Certificate of Appropriateness

Property	2205 N. LAKE DR.	North Point South HD
Description of work	<ol style="list-style-type: none"> 1. Re-clad a sided area on the north elevation with new clear cedar, to be painted upon completion. 2. Replace three windows at the west end of the south elevation with taller windows to match heights of other windows on the same floor. 2. Replace two kitchen windows with smaller windows in similar design to existing with new size being approximately 89"x45" 4. Replace aluminum storms with new wood storms. Model to be determined. 	
Date issued	2/8/19	PTS ID 114621 COA: windows and repairs

FIG. 1 South Elevation facing Kenilworth Place

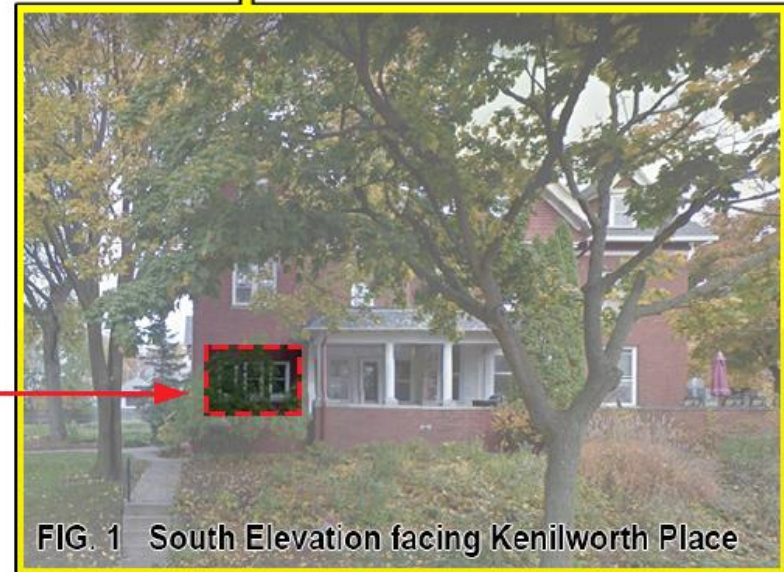
The head of these three windows will be raised to match adjacent window head height around the corner on the west elevation. See Appendix 2 for more information.

Three new all-wood windows to fix existing width and be 22-1/2"W x 45"H. Height will increase from existing.

These three windows on the south elevation will be modified.

The head of the three windows will be raised to match adjacent windows around the corner. Existing windows will be replaced with new taller windows to match the head height of adjacent windows. New windows to match existing character and style. Existing window sills to remain as is.

1. Restore brick headers using salvaged brick for enlarged windows.
2. Storm windows shall have a wood frame with sash heights that match primary windows
3. New windows will be all-wood, inside and out. No cladding of any kind and no synthetic material or metal is permitted on the exterior.

FIG. 3 View of the bay looking towards southeast direction

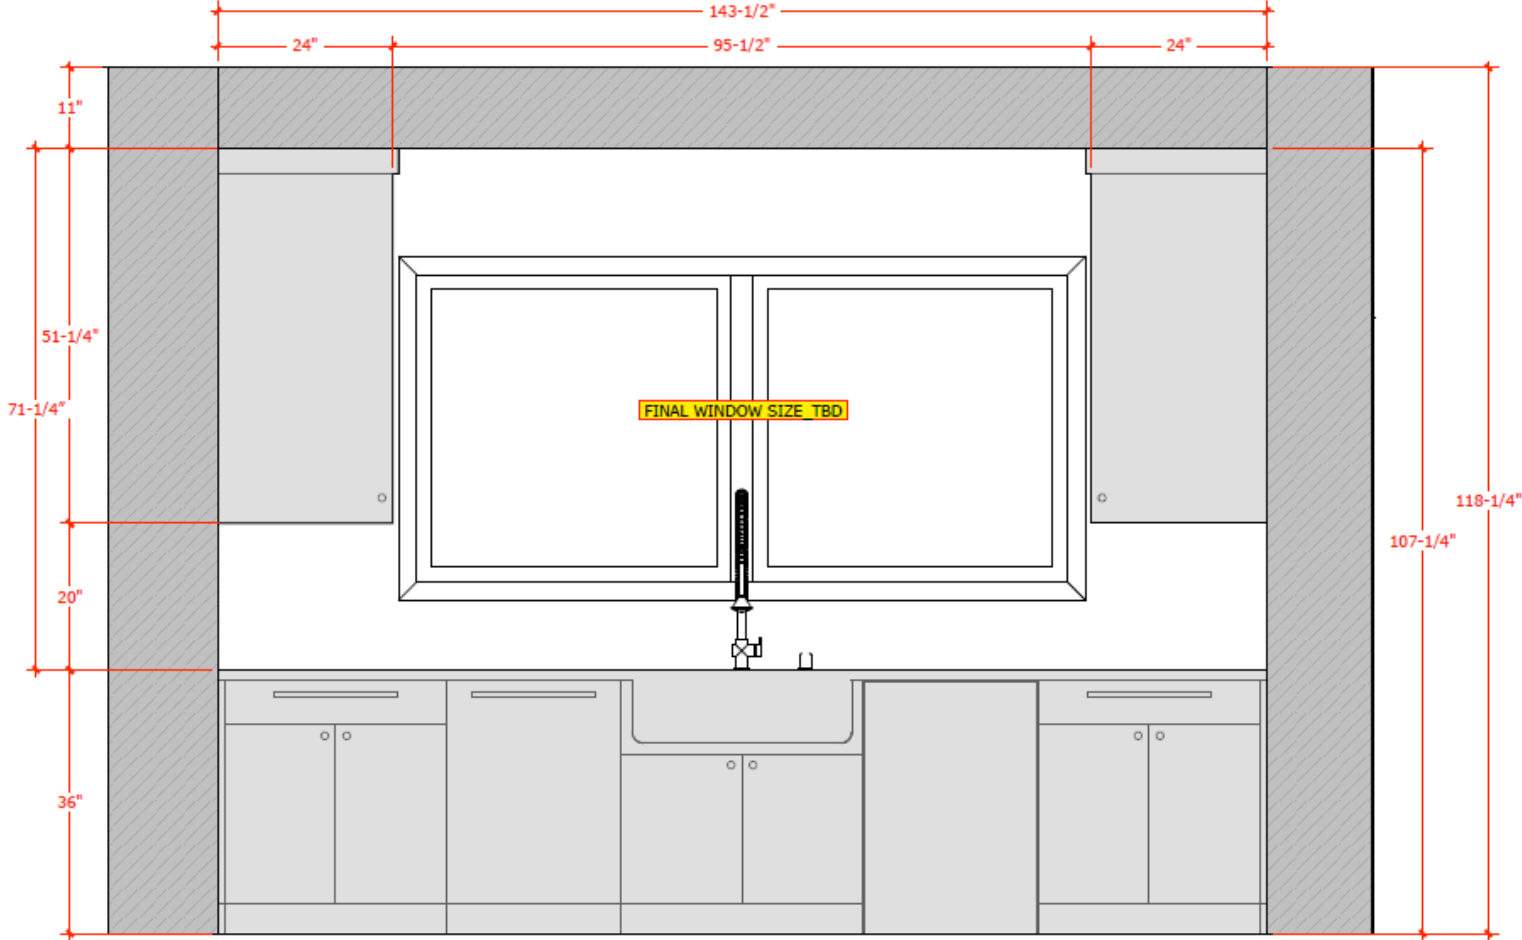
The siding and the window of this bay will be replaced. See Appendix 3, 4 and 5 for more information.

Replace windows in kitchen (wood-sided area) with new all-wood windows, approximately 89x45. No slider windows are permitted.

Replace existing wood siding with new clear cedar siding.
